Release Notes

Updated Firmware (H_7816) for cameras: V988B-W311MIR, V988D-W311MIR, V988-W-NL V985D-W311MIR and V985B-W311MIR

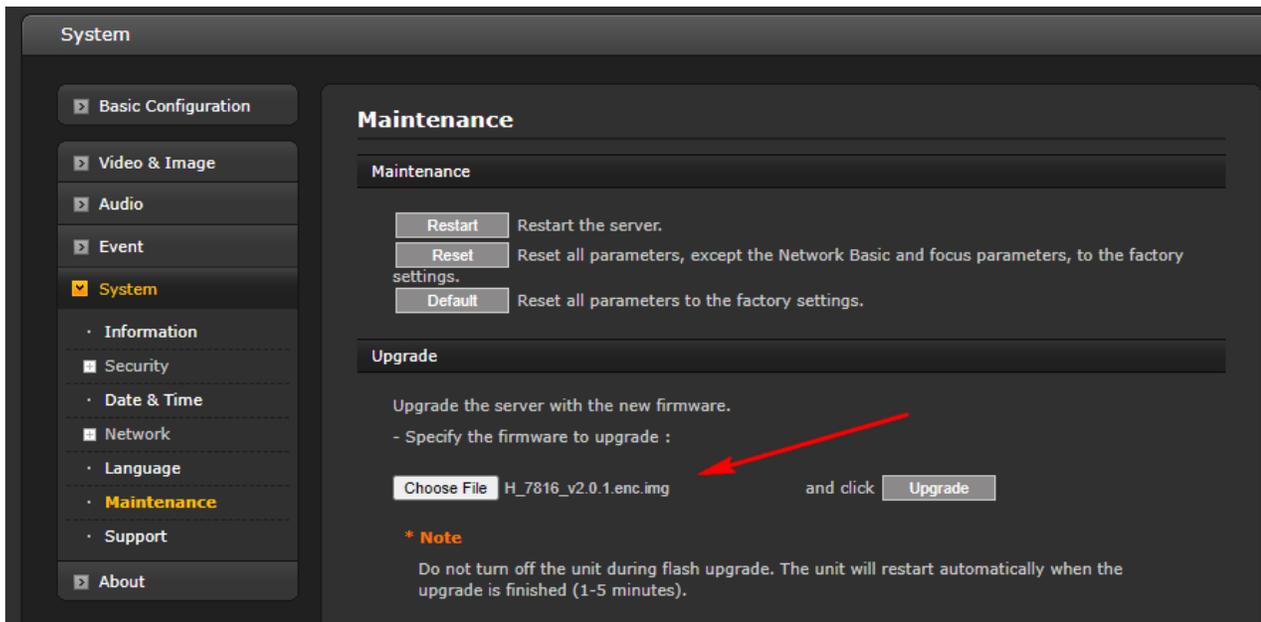
Download the firmware to your PC. Go to the camera's Maintenance screen:

Open the Upgrade section and use the Browse button to locate the firmware on your PC. Press the upgrade button. During the upgrade process, do not turn off power to the camera. Wait at least 5 minutes and access the camera again.
